## BCA ASSESSMENT REPORT

OAKDALE SOUTH ESTATE  
SITE 3A - SIGMA  
MILNER AVENUE, HORSLEY PARK

PREPARED FOR:  
GOODMAN PROPERTY SERVICES (AUST) PTY LTD

Revision 2

## 8. Clause C2.4 - Requirements for Open Spaces & Vehicular Access

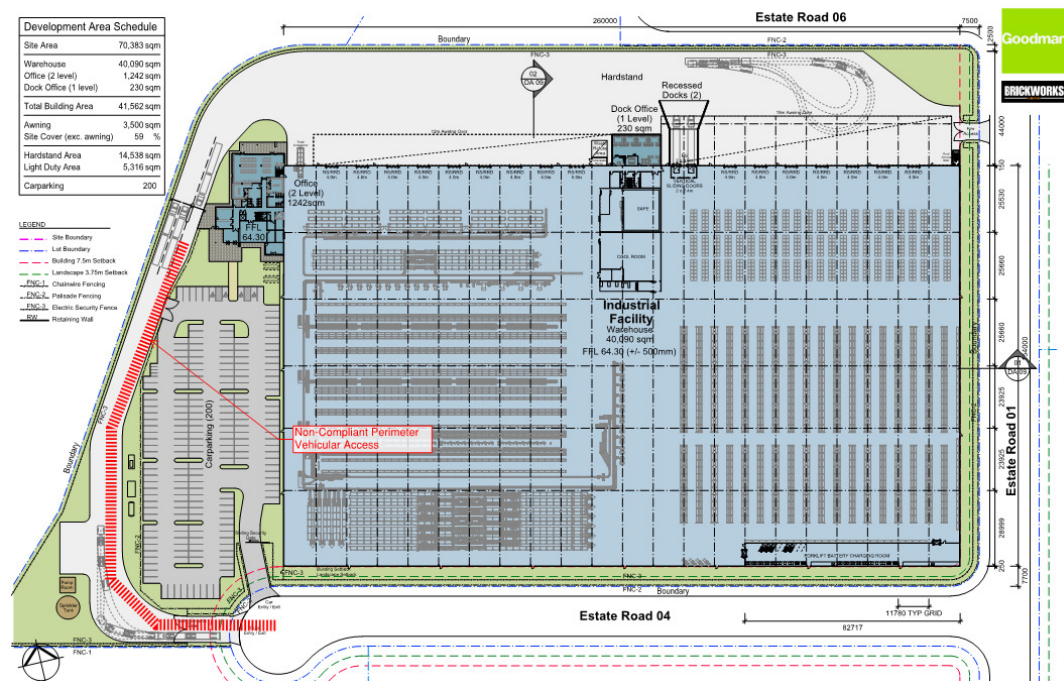
*Comments: It will be necessary for an alternative solution to be prepared to address these non-compliance issues below, in order to demonstrate compliance with Performance Requirement CP9. The departures from this clause are as follows:*

- + The vehicle access in the SW corner and western side of the building is greater than 18m from the building as circled below.

#### **11. Clause D1.4 – Exit Travel Distances**

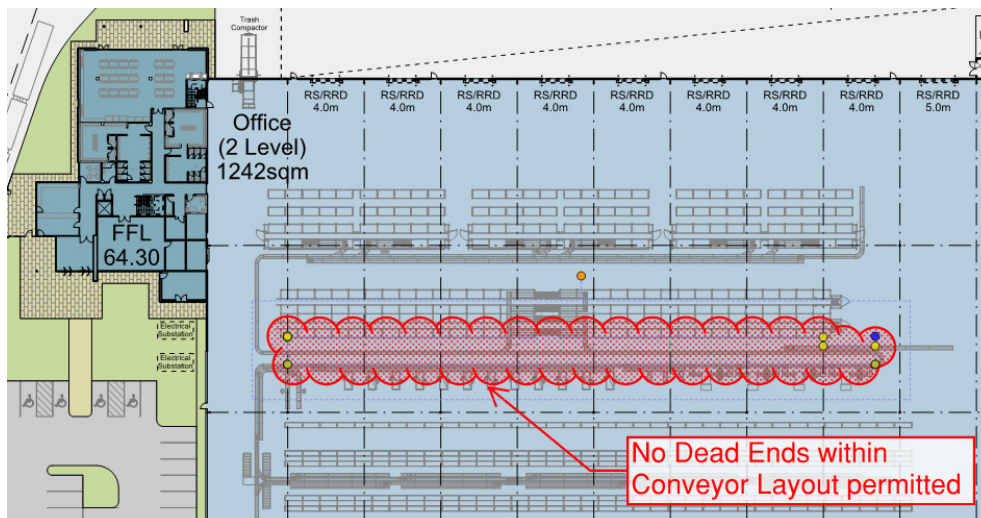
Comments: The proposed building does not comply with the 40m exit travel distance requirement under this clause, as follows:

- + Warehouse (Ground Floor) – Maximum travel distance of 95m to the nearest exit.

- + Safe (Ground Floor – Warehouse) – Distance to a point of choice to alternative exits – 34m.

Note: The above exit travel distance assessment is conditional upon no “dead-end” areas within the conveyors in the western portion of the warehouse – see example below.

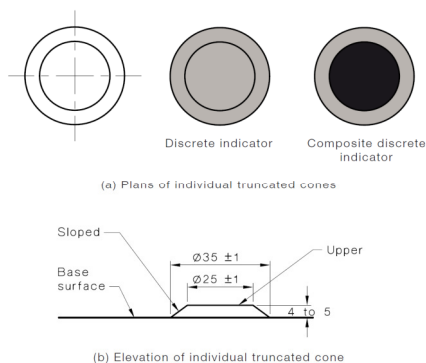
Tactile indicators will need to be provided to the mezzanine stairway. Indicators must be Type B and installed in accordance with AS 1428.4.
